Energy Fuels Resources (USA) Inc.  
225 Union Blvd. Suite 600  
Lakewood, CO, US, 80228  
303 974 2140  
[www.energyfuels.com](http://www.energyfuels.com)

June 5, 2014

Re: Response to Utah Division of Radiation Control (“DRC”) March 19, 2014 Request for Information (“RFI”), regarding the DRC review of the July 2012 Revised Renewal Application for the White Mesa Mill Groundwater Discharge Permit UGW370004

APPROVED	DATE	REFERENCE	H:718000/71802/ 2014_GWDP_renewal_app/Uwelloc14.srf	FIGURE	10
----------	------	-----------	--	--------	----

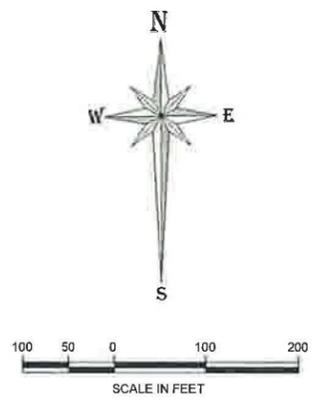
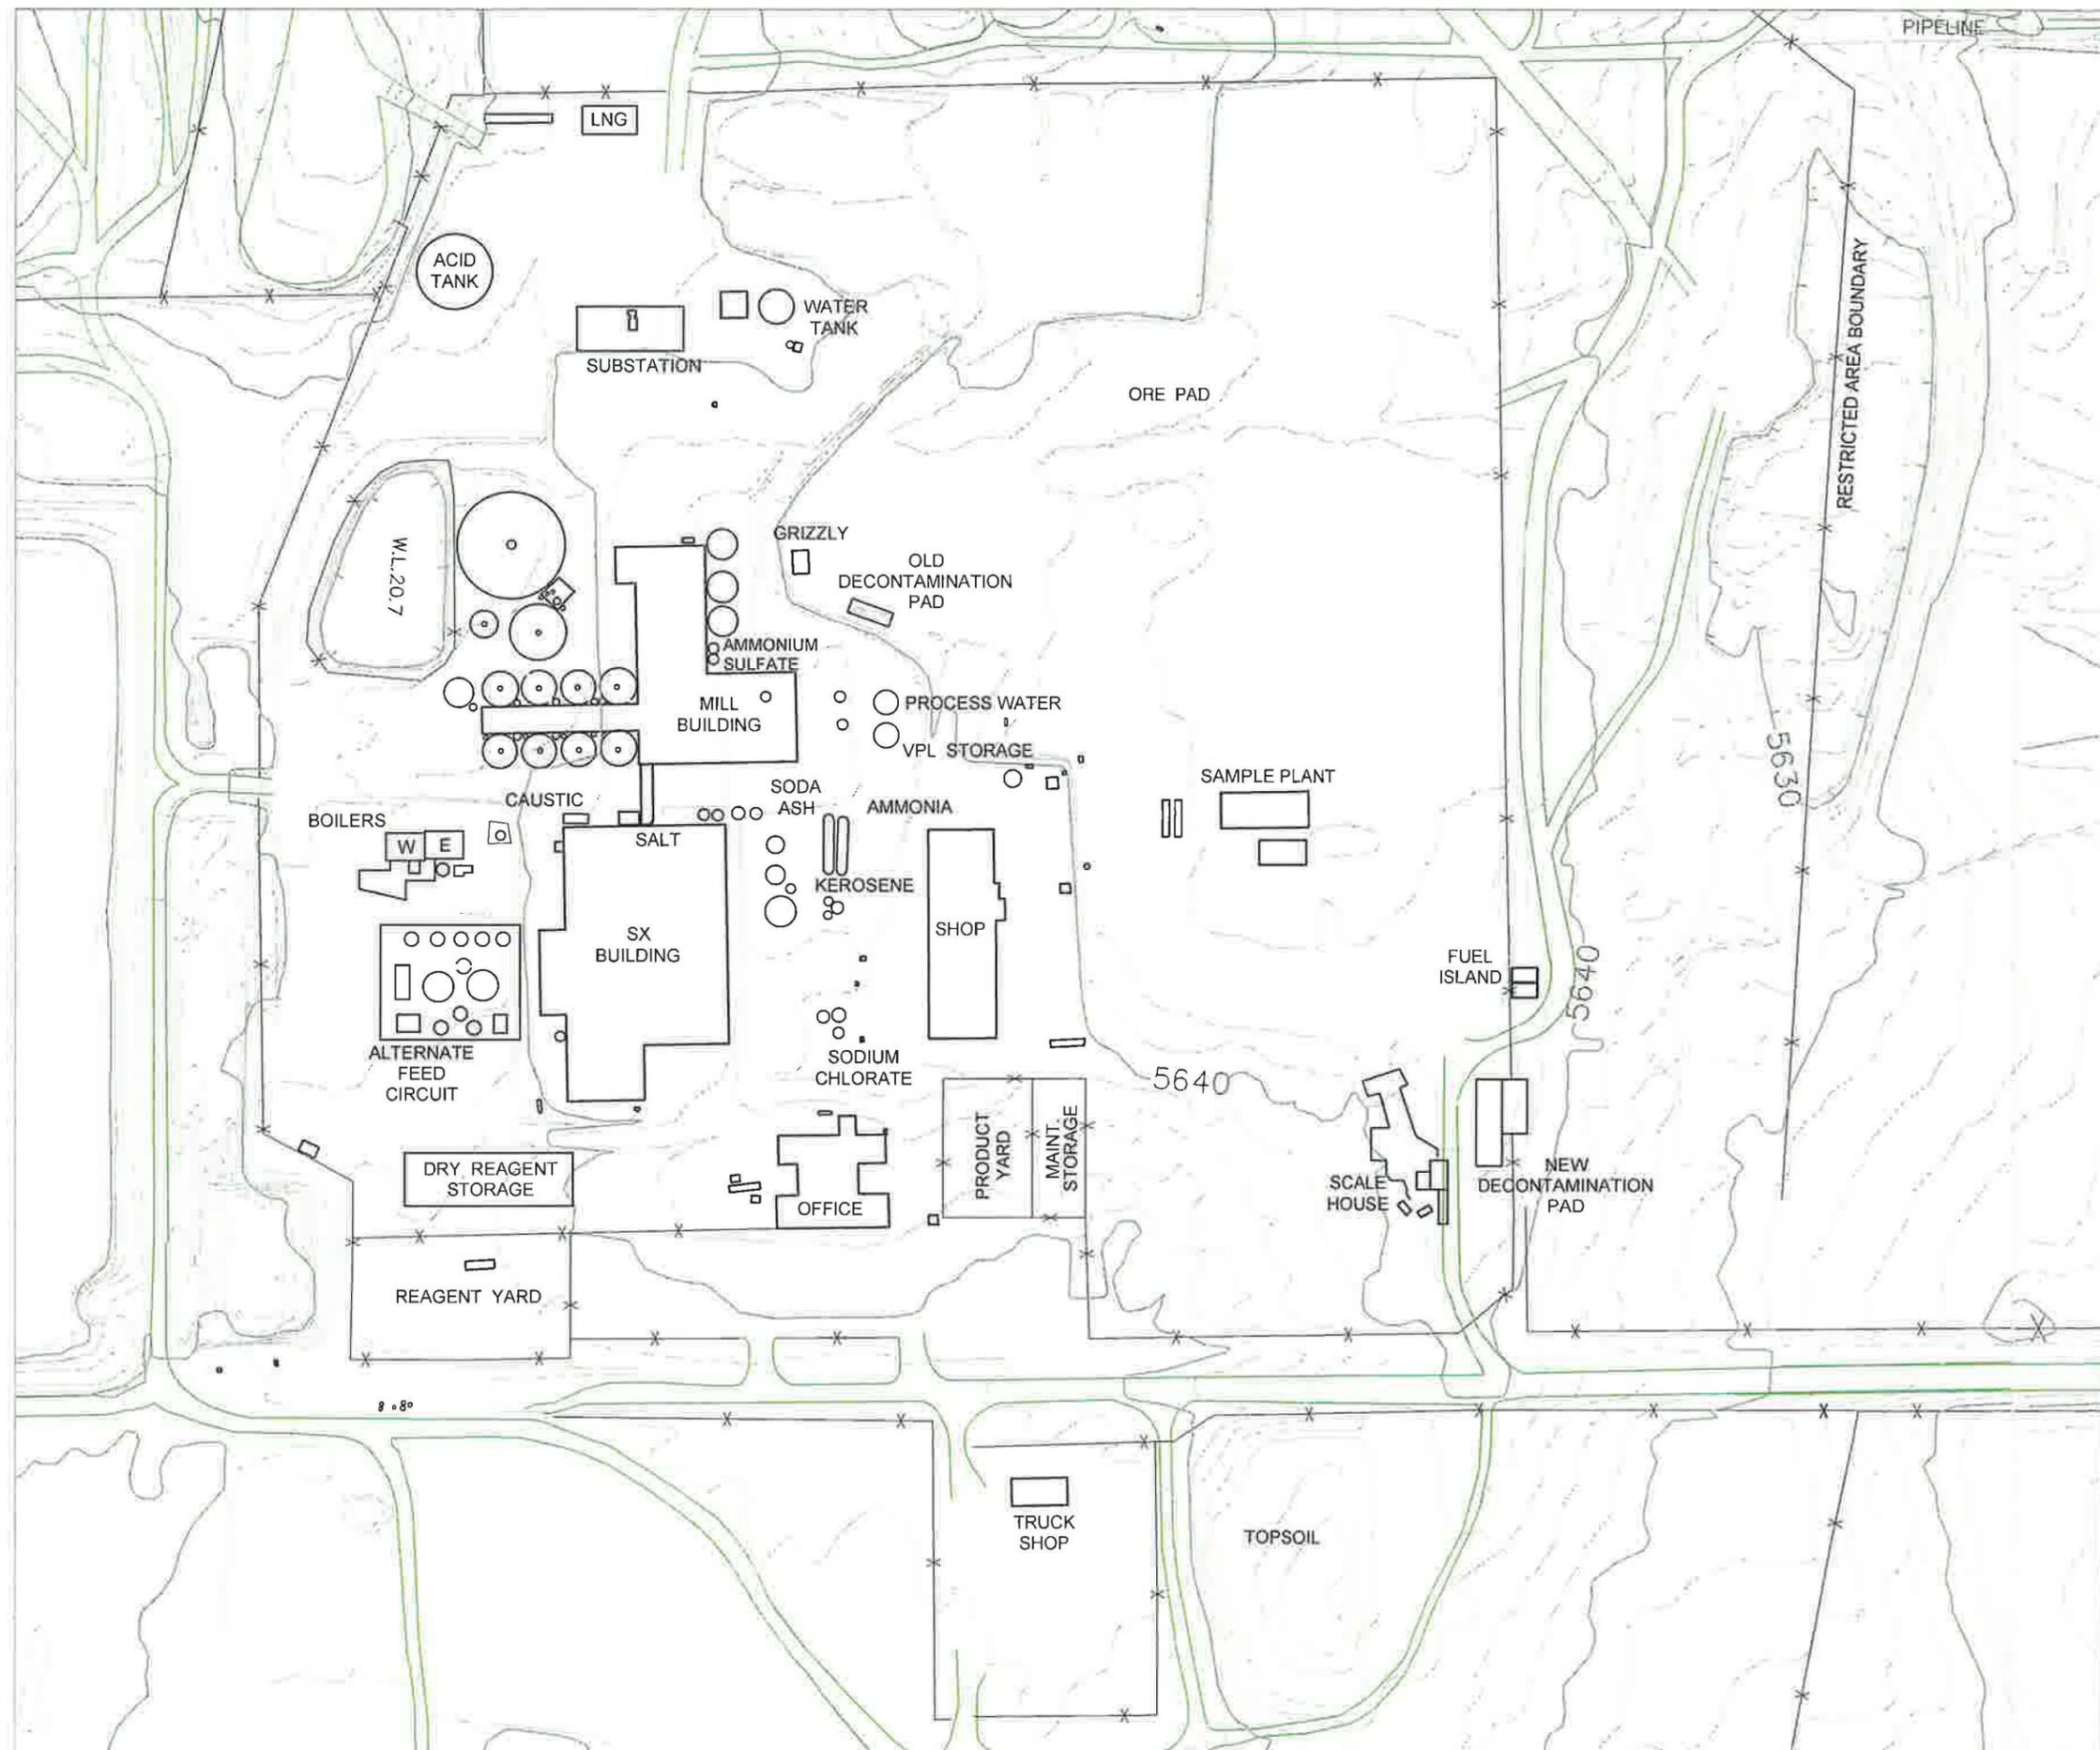
***INTERROGATORY STATEMENT(S):*** A number of apparent discrepancies exist between well locations shown in San Juan County plats in Appendix A and well locations shown in Figure 10, White Mesa Site Plan Showing Locations of Perched Wells and Piezometers. Please reconcile these, or provide explanations, if information provided is believed to be correct as is.

***BASIS FOR INTERROGATORY:*** There are several types of discrepancies noted when comparing well locations in San Juan County plats in Appendix A of the RA and well locations shown in Figure 10 of the RA, entitled White Mesa Site Plan Showing Locations of Perched Wells and Piezometers.

- *The following abandoned wells are shown as wells in San Juan County plats but are not shown in Figure 10:*

*While it is not necessary from the perspective of the DRC for EFR to take any action on mapping of these wells, since they are abandoned, the DRC does point out the apparent discrepancy between the county plats and Figure 10 with respect to their apparent existence.*
